REQUEST

Current Zoning: R-3 (single family residential)
Proposed Zoning: INST(CD) (institutional, conditional)

Approximately 5.24 acres located at the northwest intersection of Mallard Creek Road and Hubbard Road, south of West W.T. Harris Boulevard, and east of West Sugar Creek Road.

The petition proposes a residential independent living facility with up to 107 units in one building with a density of 20.4 dwelling units per acre.

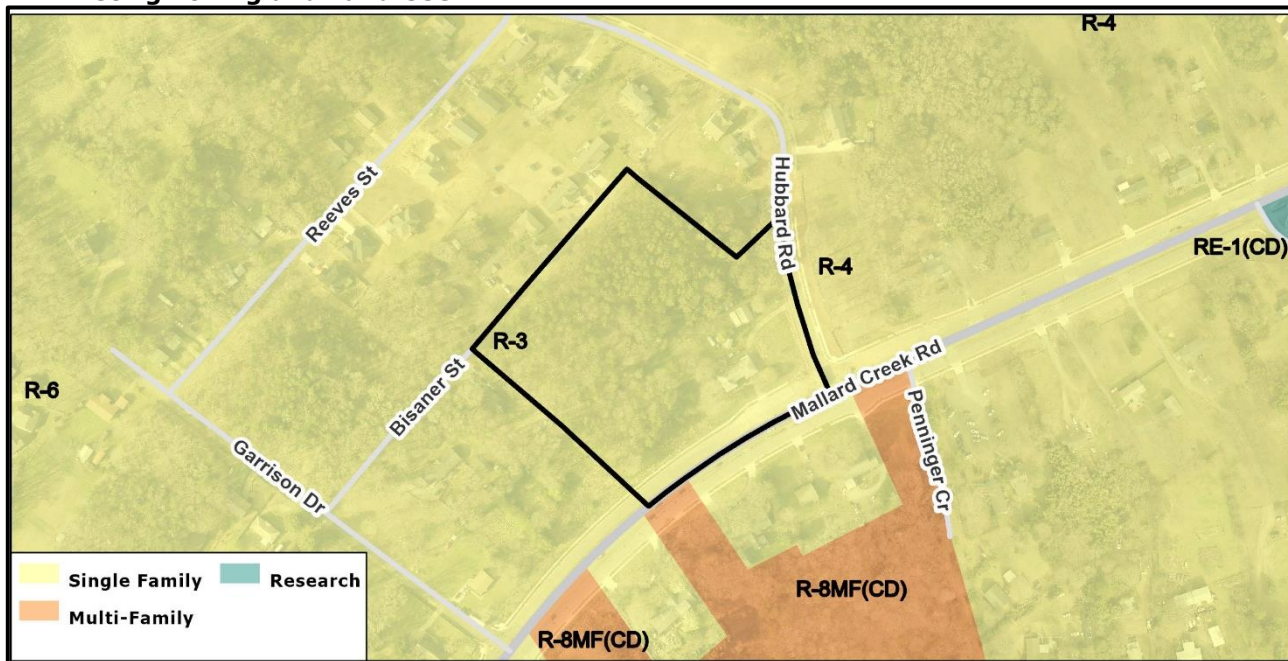
The site plan accompanying this petition contains the following provisions:

- Allows 107 age-restricted units in one building.
- Limits building height to 60-feet.
- Provides an ADA compliant bus pad on Mallard Creek Road.
- Commits to an eight-foot planting strip and a 12-foot multi-use path alongside Mallard Creek Road, and an 8-foot sidewalk and an 8-foot planting strip alongside Hubbard Road.

- Access is provided by a driveway on Hubbard Street and Mallard Creek Road as right-in/right-out.
- Provides a minimum 3,500 of improved open space with walking paths, landscaping, and seating area.

- Provides a 32-foot Class C buffer along the property boundaries that abut single family zoning or use.
- Architectural Details:
 - Building materials will be a combination of portions of some of the following: brick, stone, precast stone, precast concrete, synthetic stone, cementitious fiber board, stucco, EIFS, decorative block and/or wood.
